SWPPP COMPLIANCE INSPECTION FORM

Project Name:	Reed Baron	Address:	2548 N Elkhorn Trail Eden, Utah	Date:	9/5/2012
Owner:	Private	Contractor (Gen/Sub):	Reed Baron	Start time:	3:47 PM
Site Contact:	Reed Baron	Phone:	602-692-3572	Stop time:	
UPDES Permit #:	UTR360513	Expiration:	6/11/2013	Weather:	Sunny Cloudy Raining Snowing Other:
Date of last rain event:	9/1/2012	Duration:		Approx. Rainfall (in):	0.41"
Inspected By (Print):	Rochelle Pfeaster	Local Jurisdiction or County:	Weber County		
Reason for Inspection:	Scheduled	Complaint/Tip	Random	Receiving Waters:	Weber River
Inspection Code (circle):	SW sampling SW non-sampling	Inspector Code (circle):	(S) State (L) Local	Type Code (circle):	1 - Municipal 2 - Industrial 3 - State

Tracking on the county road

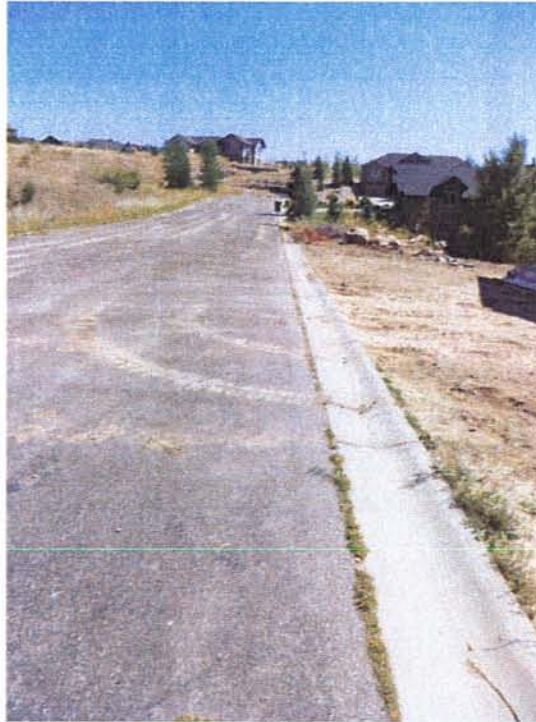
There was sort of a SWPPP on site for me to look at but I didn't see the plan itself or any inspections, I did see a log of changes which looks to be current. The was tracking evident on the road, and the rolled gutter has dirt in it. Looks like the silt fence is still in need of repair. Please get the site perimeter cleaned up and make necessary repairs for my next inspection.
